## molex

### **Product Change Notification**

Date Issued: February 01, 2024 **PCN Number:** 514268 Reason for Change: Manufacturing Process Change (Molex) Description of Change: This letter is to inform you that the manufacturing process for the part(s) identified in this notice is changing. No changes will be made to the product as a result of this process change. Reason for Short Notice: Capacity Increase Assessment of Change: No change to parts - Form/Fit/Function Planned Implementation Date: July 31, 2024 Customer Sample Availability Date: February 29, 2024

#### Overview

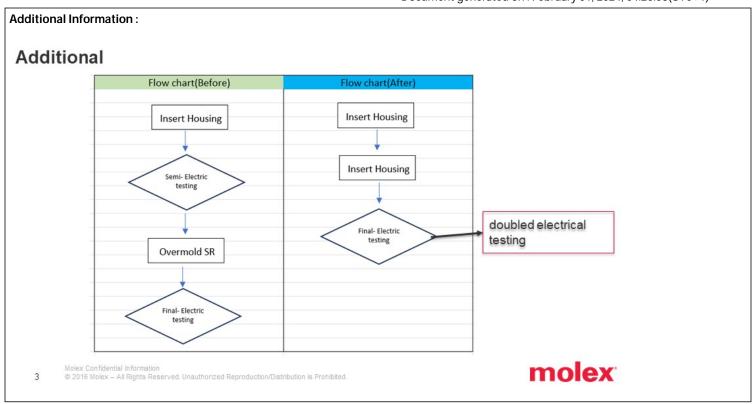
HSAL II cables have 2~3 electrical process depending on configuration and customer requirement Reduce the multiple processes by strengthening the 100% electrical testing (double test-single loading &unloading).

- · Separate electrical testing pre-&post-molding.
- Single continuity testing at semi
- Single continuity testing &4w testing Etest 1

Before

- Strengthened electrical testing(doubled electrical testing).
- Single load single unload.
- Label to print after passing.

After

- HSAL II cables have 2~3 electrical process depending on configuration and customer requirement Reduce the multiple processes by strengthening the 100% electrical testing (double test-single loading &unloading).
- Product Impact
  - There will be no impact on form, fit and function.
- Part Number Impact
  - FG Configuration list, please see the table.
